Access Compliance Report

Public Rights-of-Way

(Curb Ramps)

Intersection ID: 16672	Main Street: EAGLECREST_RD	Cross Street: REDDMAN_RD	Location: S
ADA ID: 754F9C149D14	Ramp Type: PerpDiag	Initial Pass/Fail: Fail	Overall Compliance: No
Severity Score: 58.75			
Codes/Mitigation Info/Possible Solution		Field Measurements/Component Compliance

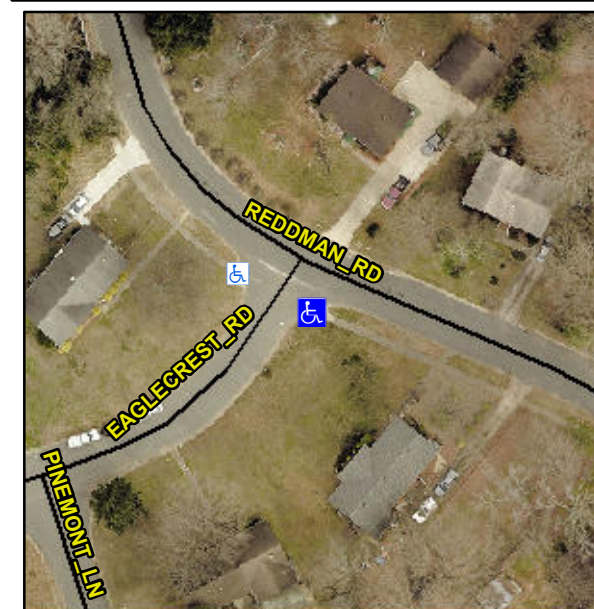
Not Found, R304.5.1, R304.2.2, R304.5.3

Compliance	Description	Data	Compliance	Description	Data
N/A	Ramp Length (in)	67.0	No	Ramp Slope (%)	14.9
No	Ramp Width (in)	47.0	No	Ramp XSlope (%)	9.0
N/A	Flare Type LT	N/A	N/A	Flare Type RT	N/A
N/A	Flare Slope LT (%)	N/A	N/A	Flare Slope RT (%)	N/A
N/A	Flare Traversable LT?	N/A	N/A	Flare Traversable RT?	N/A
N/A	Landing Length (in)	N/A	N/A	DWS Provided?	N/A
N/A	Landing Width (in)	N/A	N/A	DWS Contrast?	N/A
N/A	Landing Slope (%)	N/A	N/A	DWS Length (in)	N/A
N/A	Landing X Slope (%)	N/A	N/A	DWS Full Width?	N/A
N/A	Landing Curb? (Y/N)	N/A	N/A	DWS Offset (in)	N/A
N/A	Shared Landing?	N/A			
N/A	Gutter Ponding?	N/A	N/A	Gutter Slope (%)	N/A
N/A	Gutter Lip Ht (in)	N/A	N/A	Gutter X Slope (%)	N/A
N/A	Painted X Walk1?	No	N/A	Painted X Walk2?	No
	X Walk 1 Direction	To NE		X Walk 2 Direction	To NW
N/A	X Walk 1 Width (in)	N/A	N/A	X Walk 2 Width (in)	N/A
	X Walk 1 Slope (%)	8.8		X Walk 2 Slope (%)	4.2
	X Walk 1 X Slope (%)	5.1		X Walk 2 X Slope (%)	5.5

Remove & Replace Curb Ramp With Two New Directional Ramps or Equivalent.
